The Commission has issued the enclosed Amendment No. 59 to Provisional Operating License No. DPR-19 for Dresden Station Unit 2 and Amendment Nos. 52, 70, and 64 to Facility Operating License Nos. DPR-25, DPR-29, and DPR-30 for Dresden Station Unit 3 and Quad Cities Station Units 1 and 2, respectively. The amendments are in response to your letter of November 1, 1979.

The amendments will allow reactor power ascension to proceed along a modified power/flow line. This will facilitate adherence to procedures designed to reduce fuel pellet-clad interaction.

SAFETY EVALUATION BY THE OFFICE OF NUCLEAR REACTOR REGULATION

SUPPORTING AMENDMENT NO. 59 TO PROVISIONAL OPERATING LICENSE NO. DPR-19

FIGURE 2.1-3 (SCHEMATIC)

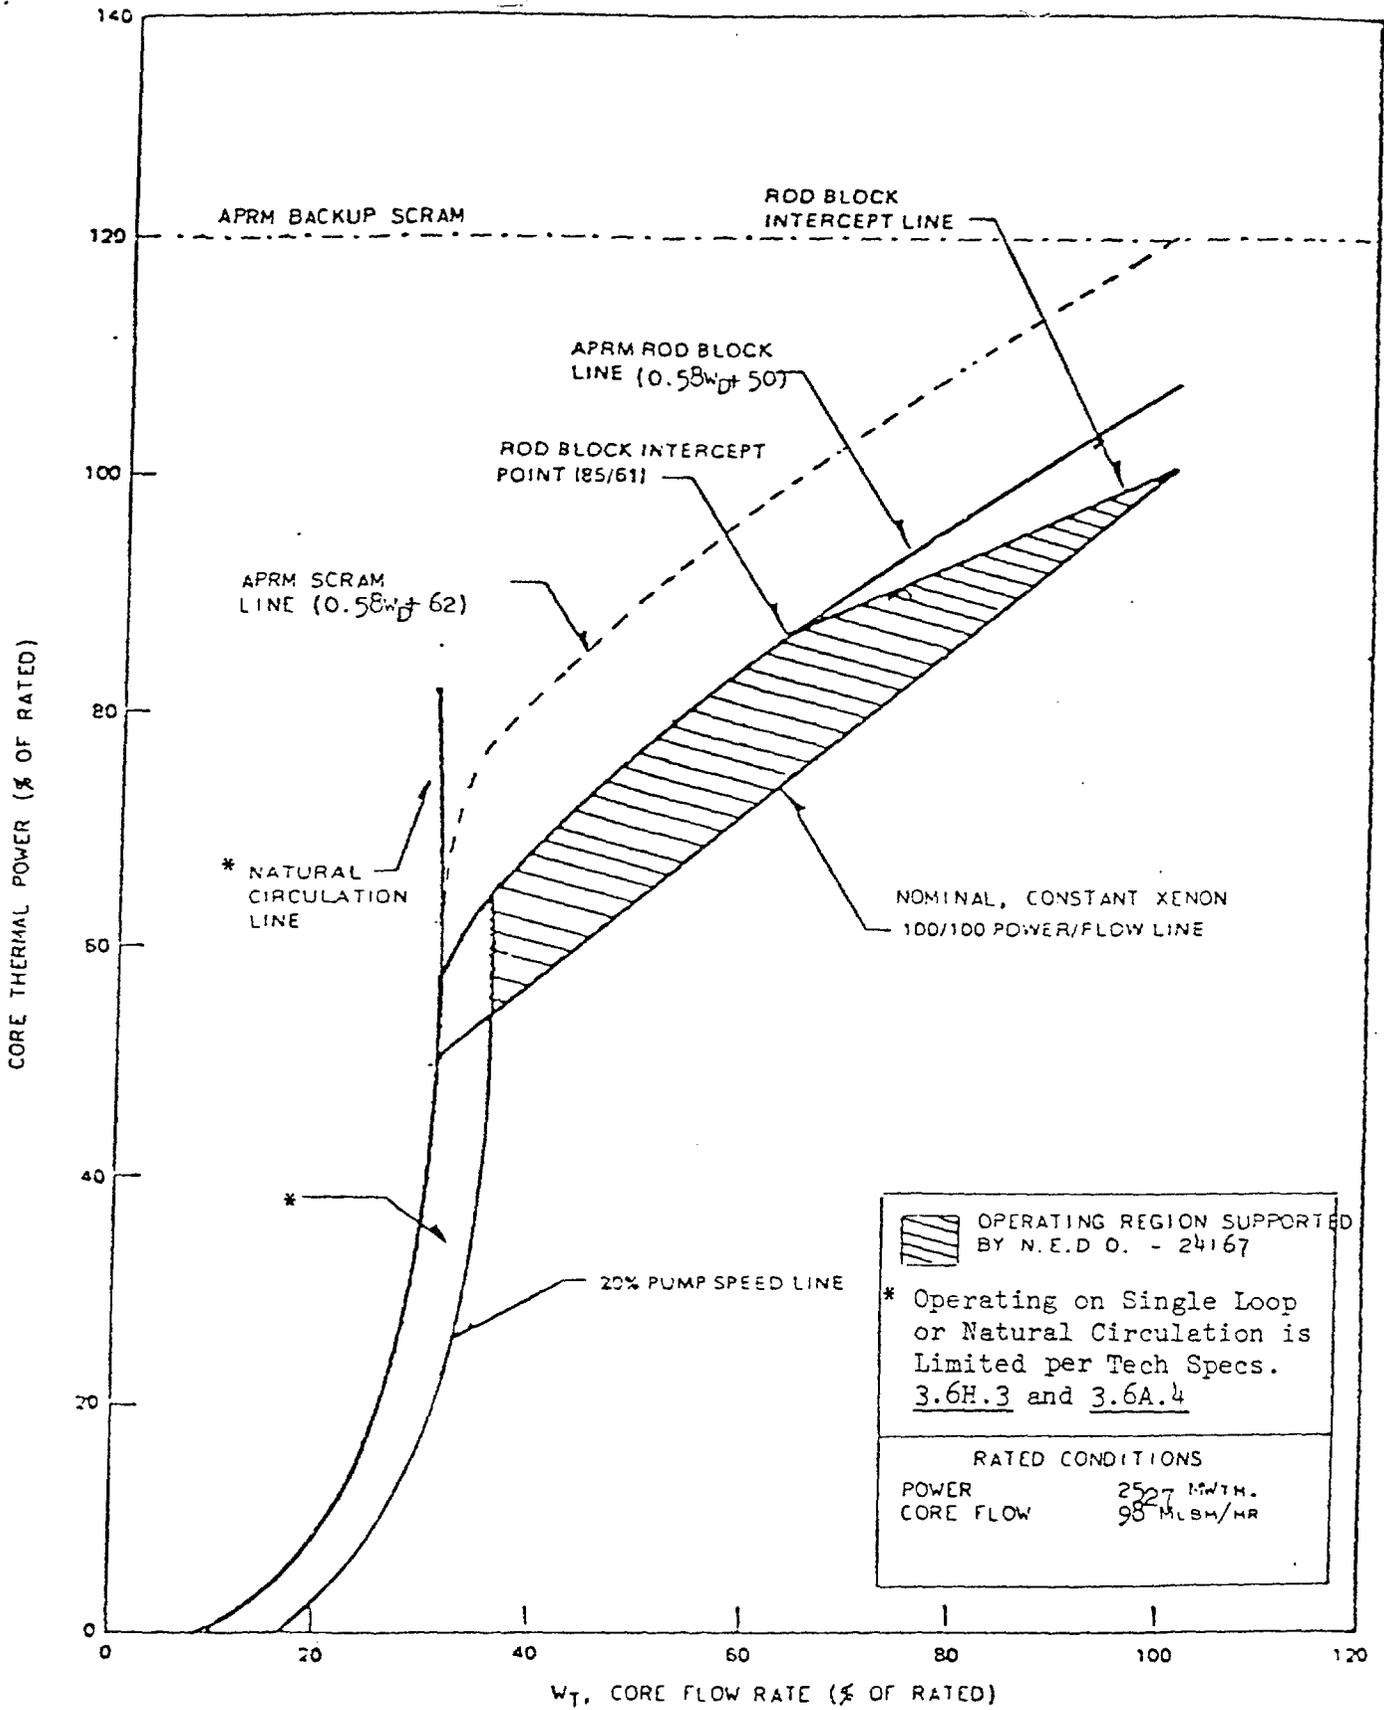
$$S \leq [.58W_D + 50]$$

$$S \leq (.58W_D + 50) \left[\frac{FRP}{MFLPD} \right]$$

FIGURE 2.1-3 (SCHEMATIC)

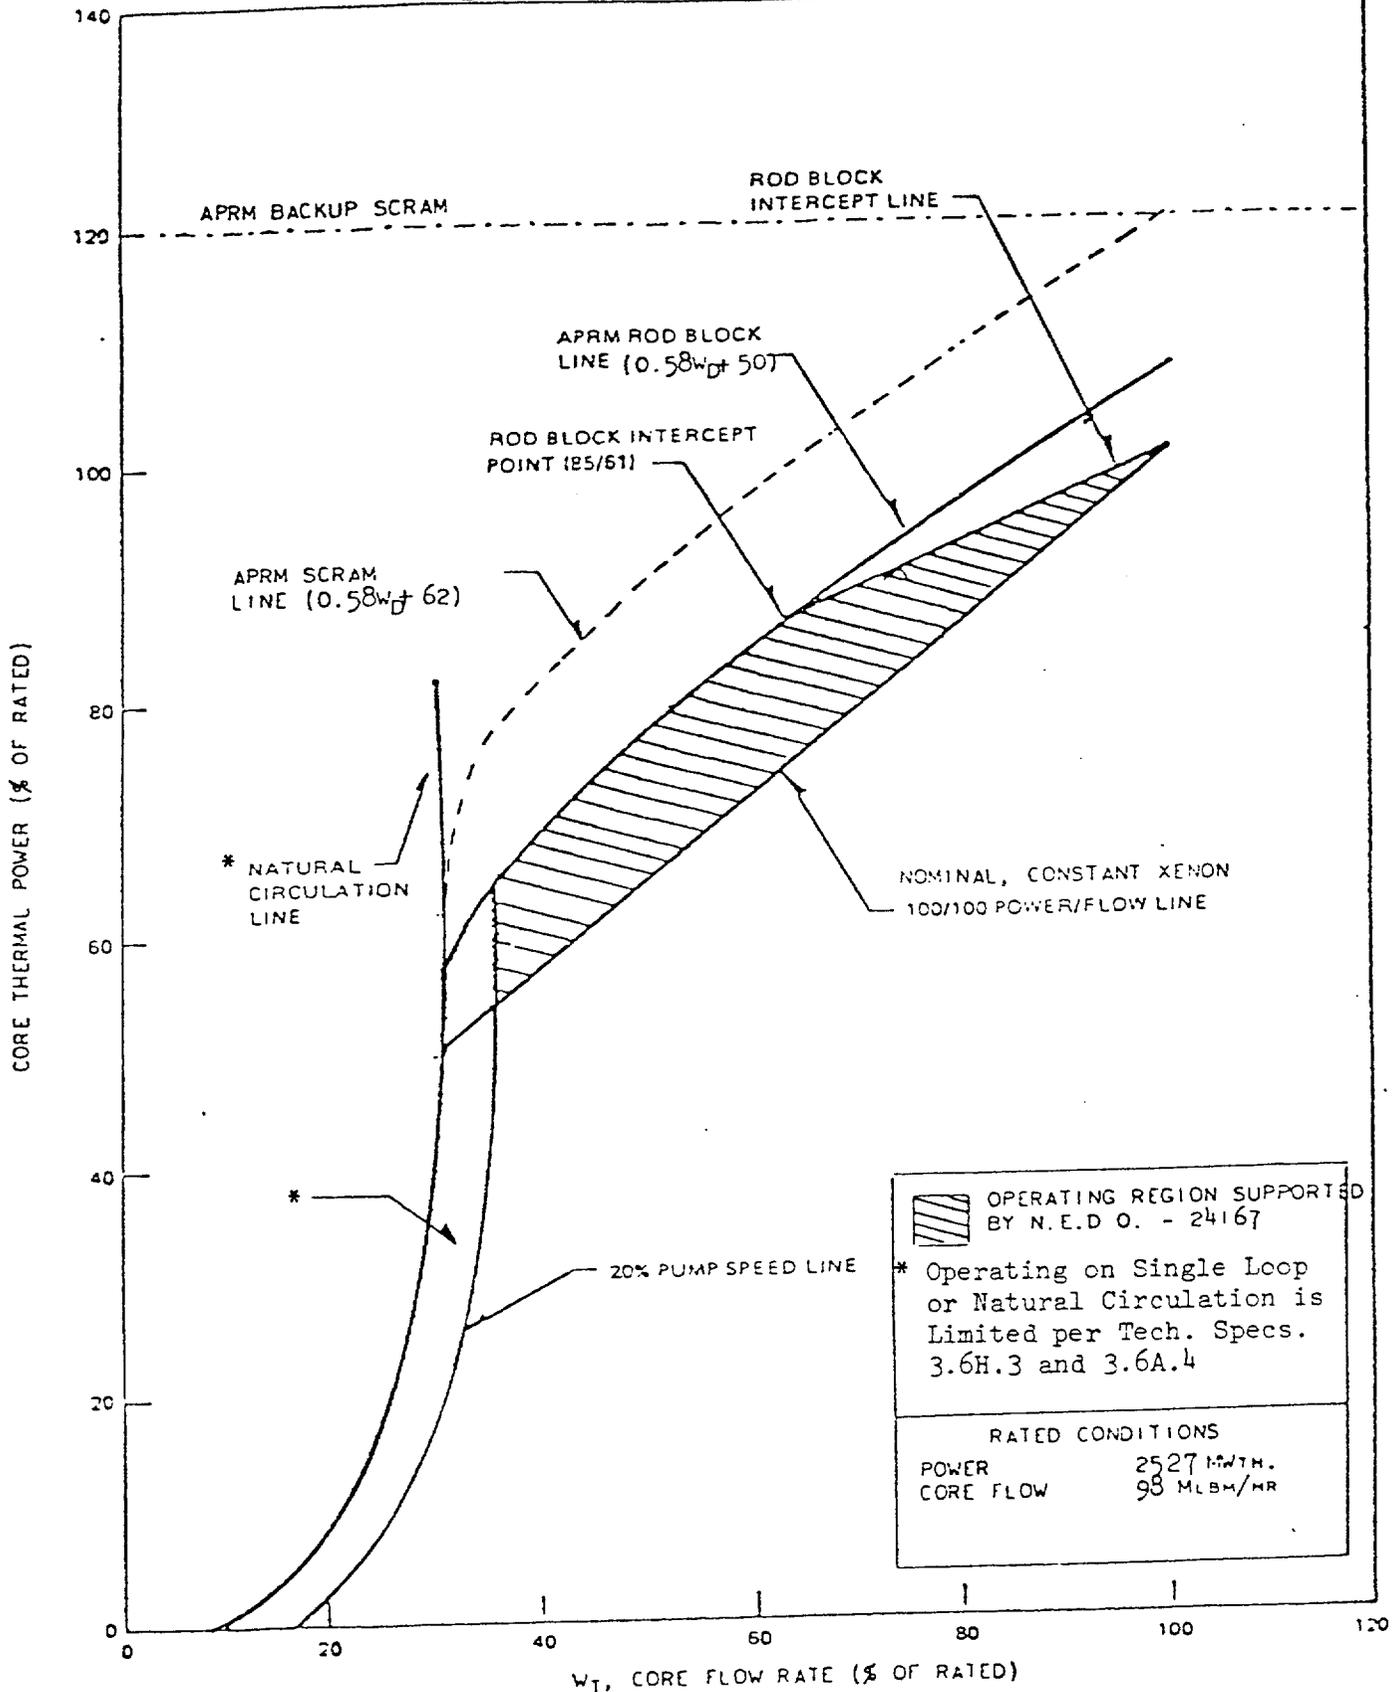
$$S \leq [.58W_D + 50]$$

$$S \leq (.58W_D + 50) \left[\frac{FRP}{MFLPD} \right]$$

FIGURE 2.1-1

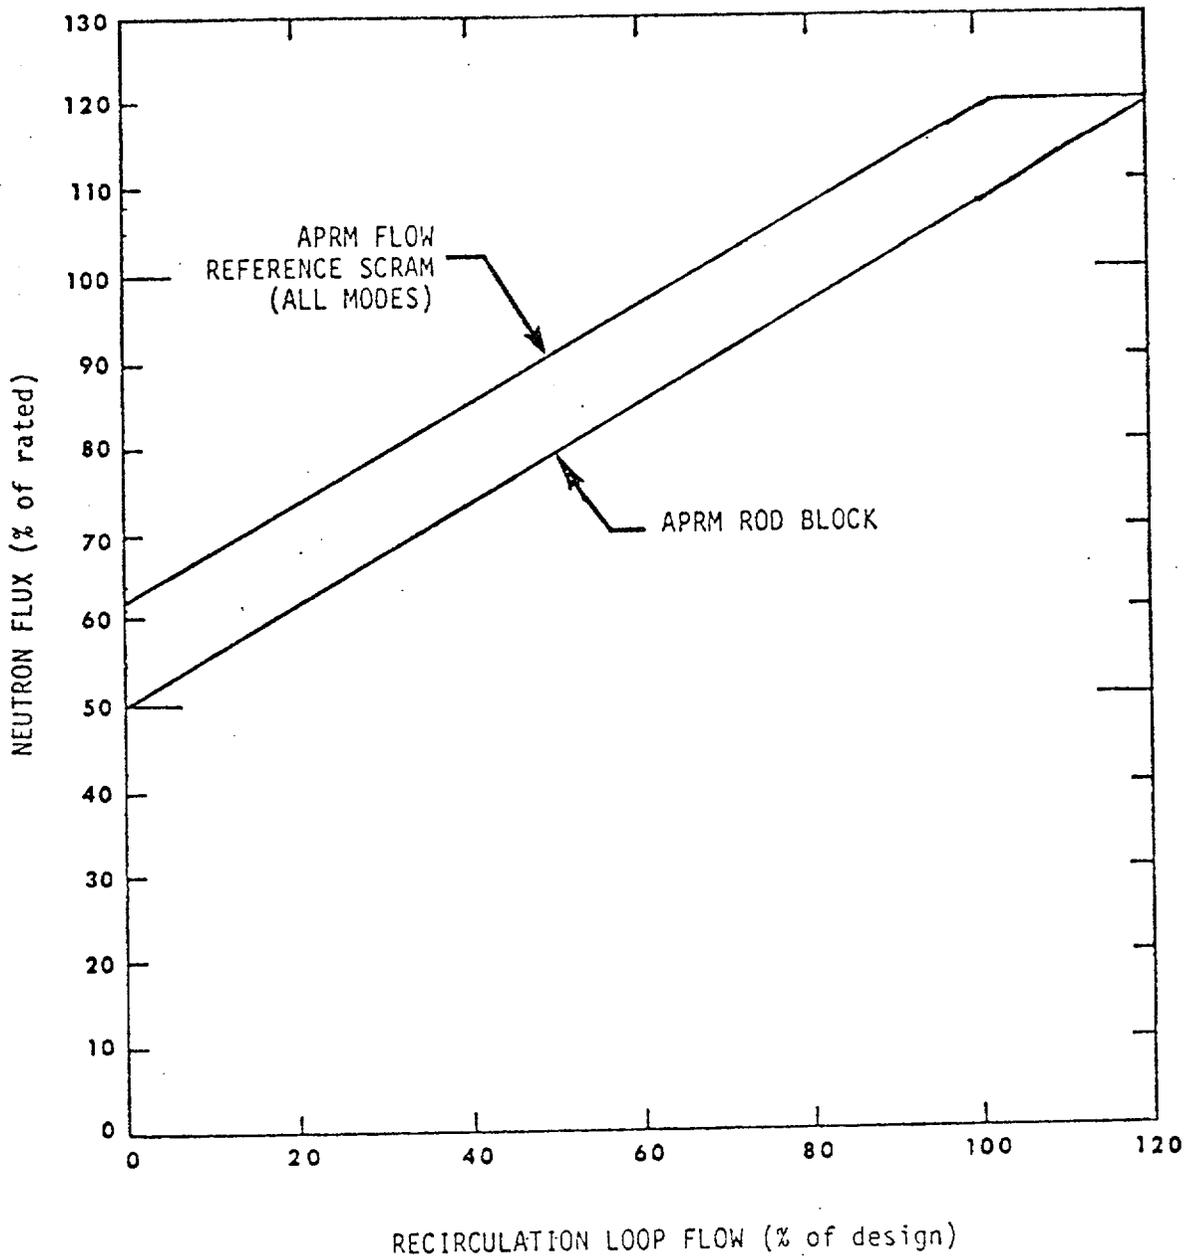
When the reactor mode switch is in the Run position, the APRM flux scram setting shall be as shown in Figure 2.1-1 and shall be:

The APRM rod block setting shall be as shown in Figure 2.1-1 and shall be:

$$S \leq (.58W_D + 50)$$

FIGURE 2.1-3
(SCHEMATIC)

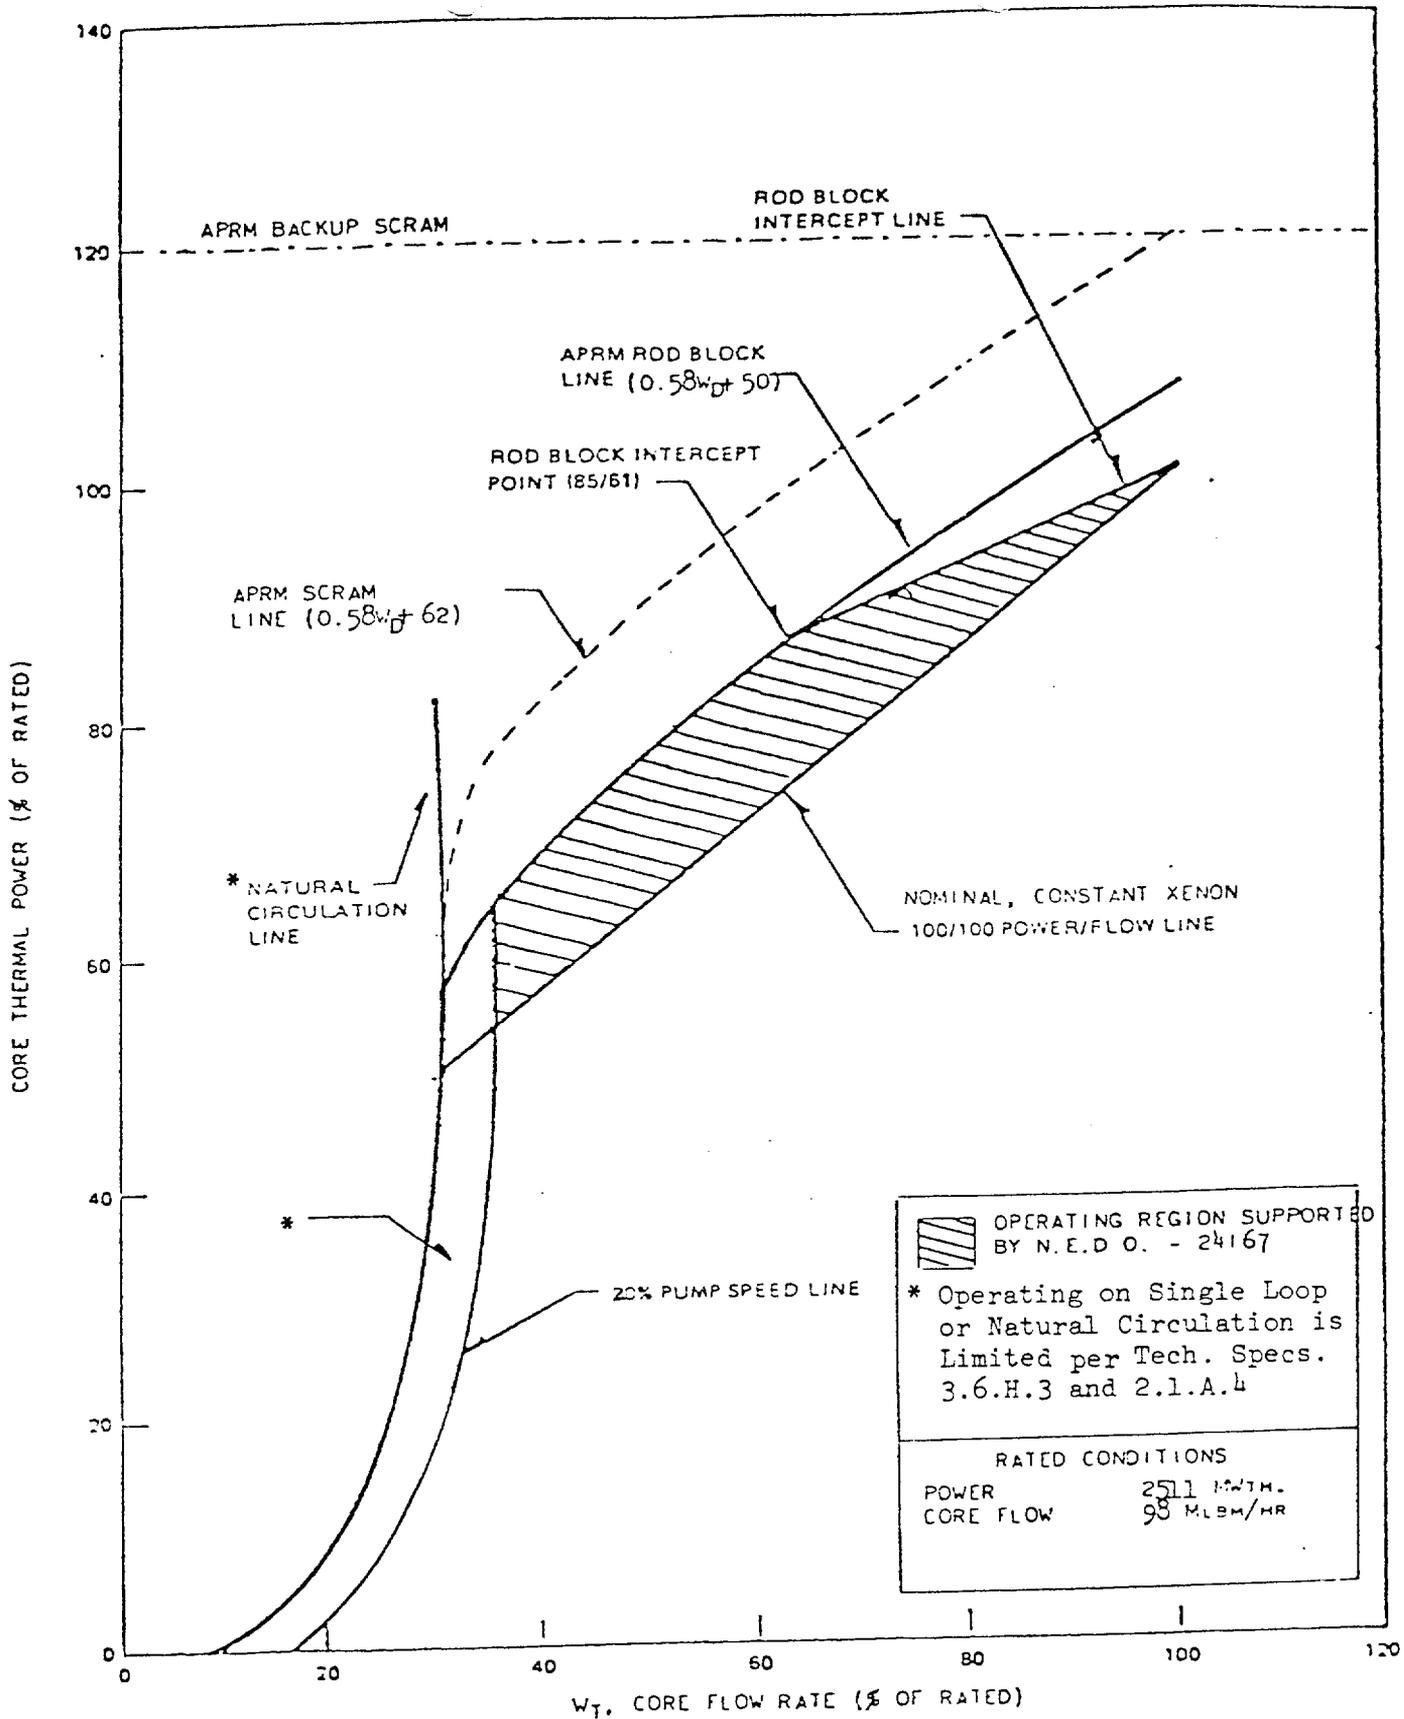
1.1/2.1-1
1.1/2.1-2
1.1/2.1-2a
Figure 2.1-1
Figure 2.1-3
3.2/4.2-14

FIGURE 2.1-1

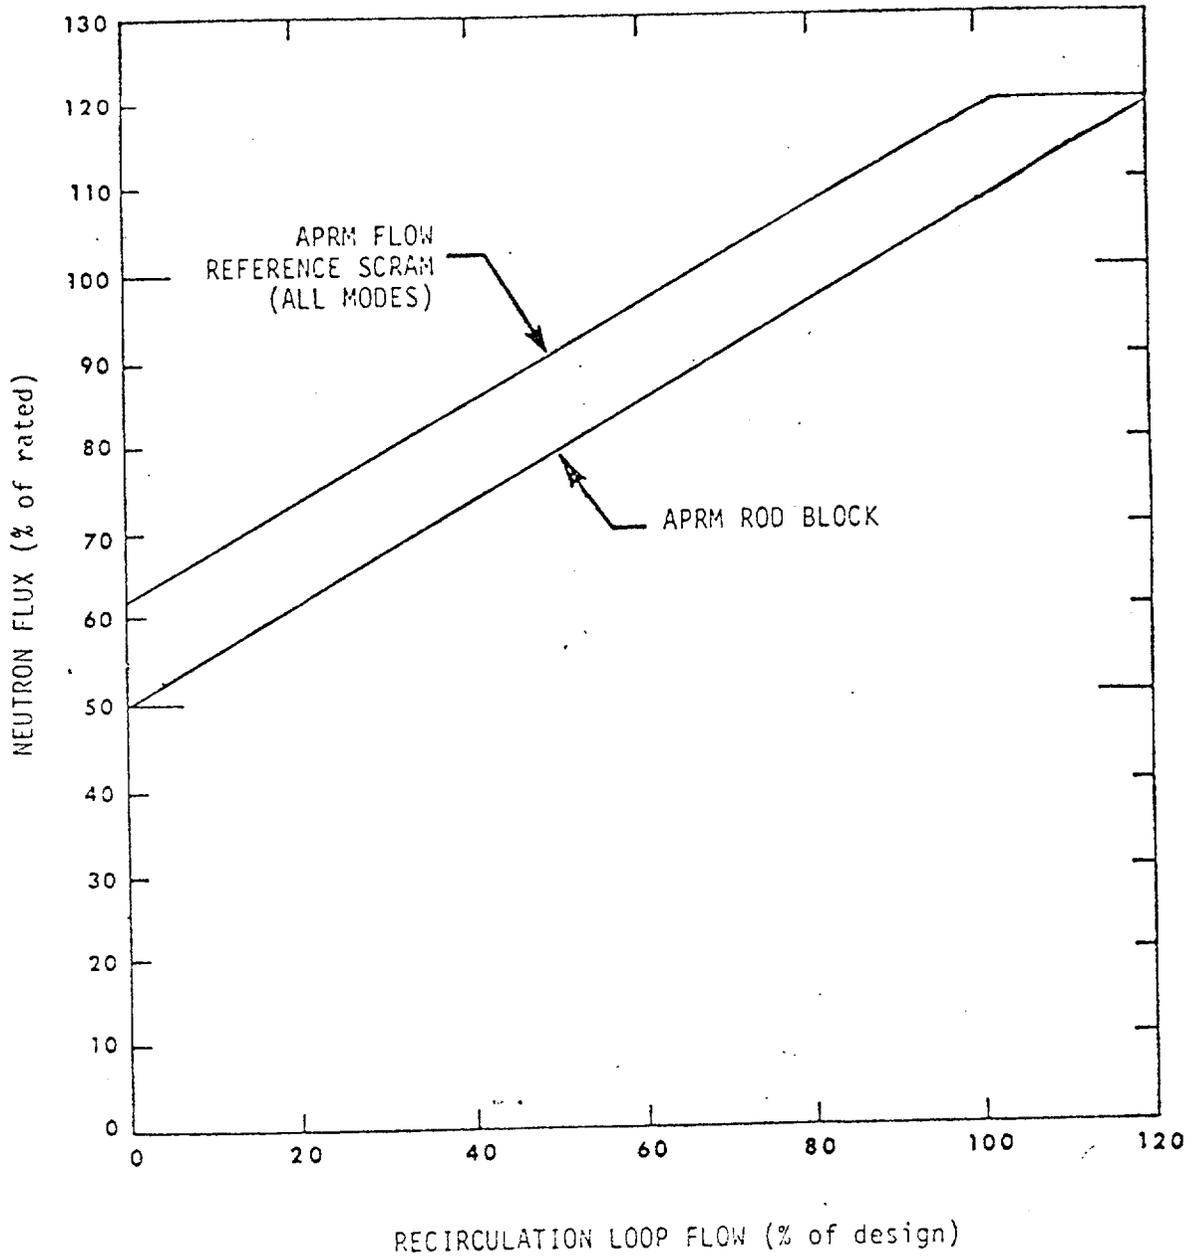
When the reactor mode switch is in the Run position, the APRM flux scram setting shall be as shown in Figure 2.1-1 and shall be:

The APRM rod block setting shall be as shown in Figure 2.1-1 and shall be:

$$S \leq (0.58W_D + 50)$$
